Delegated Report

Householder Planning Application

Application No:	20220922
Location:	180 Singlewell Road, Gravesend, Kent, DA11 7RB
Description:	Alterations to existing driveway to create an additional entrance/exit with a second dropped kerb.
Applicant:	Margaret Beighton
Site Visit:	N/A Desktop Assessment

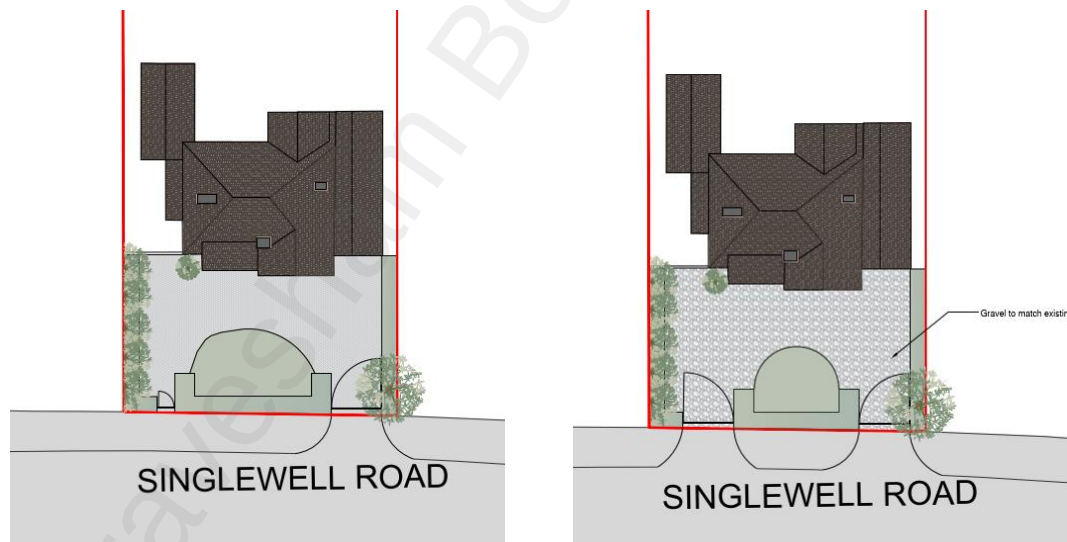
This application proposes the creation of a second gated vehicular access. The existing pedestrian access would be replaced by an additional vehicular access and dropped kerb, to create an entrance/exit driveway. The soft landscaped section on the frontage would be reduced as part of this development, as shown in the block plans below:

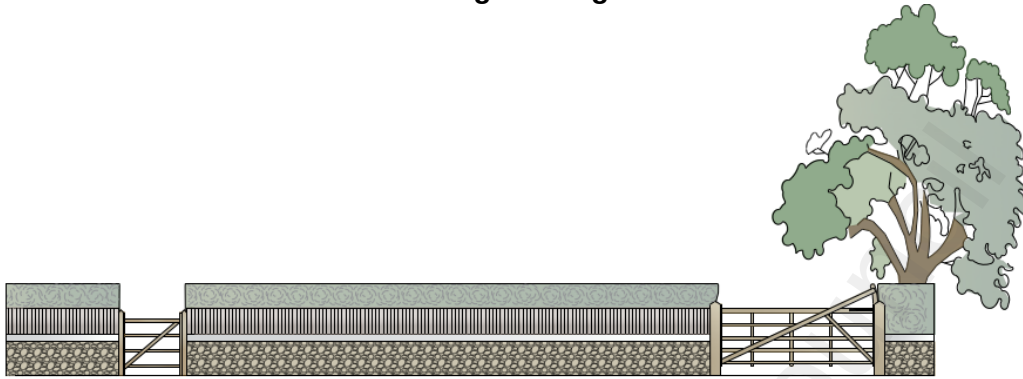
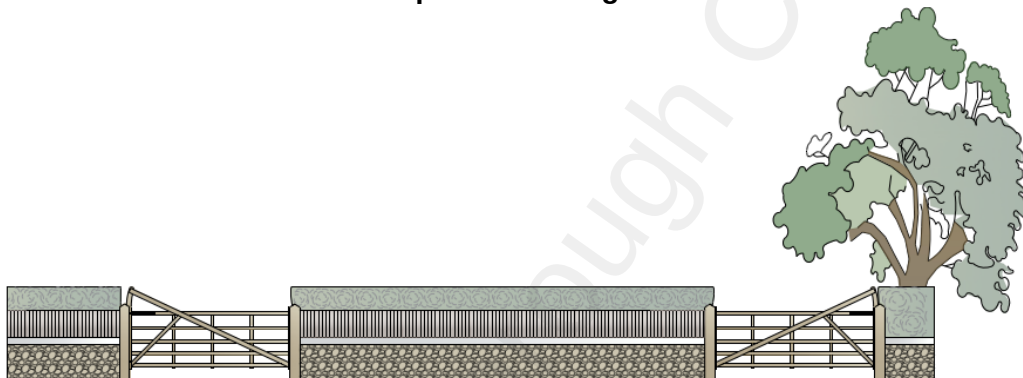
The proposed development will not significantly alter the appearance of the property's frontage. The existing pedestrian access will be widened and replaced by a larger opening for vehicles, with a gate

installed that mirrors the existing vehicular gate (as shown in the comparison screenshots below):

The central hedgerow and lawn behind will be reduced, however the frontage of the property will not materially change or impact on the street scene. The driveway will remain gravelled and the mature tree will be retained.

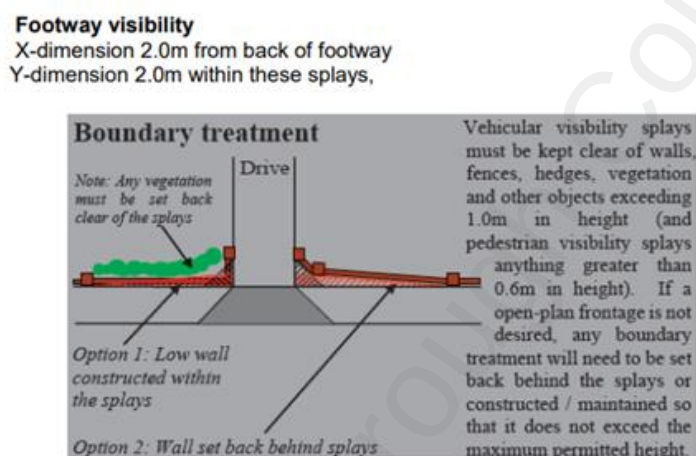
In addition, the proposed access will provide substandard pedestrian visibility splays that increase the risk of injury for users of the footway. The driveway access will have standard fencing at a height of 1.8m and some shrubbery, which limit visibility. Kent County Councils highway guidance and the Department for Transport's 'Manual for Streets' document (2007) state that footway visibility should have no obstruction above 0.6m with 2m by 2m splays, as demonstrated in the screenshot below:

The proposed access will be obstructed by the mature hedging and gates, which exceed the height of 0.6m, and concerns were raised by GBC Highways Officer and KCC Highways regarding the pedestrian visibility splays. Therefore, the proposed access is considered to be a risk to pedestrians by virtue of unacceptable visibility splays contrary to guidance.
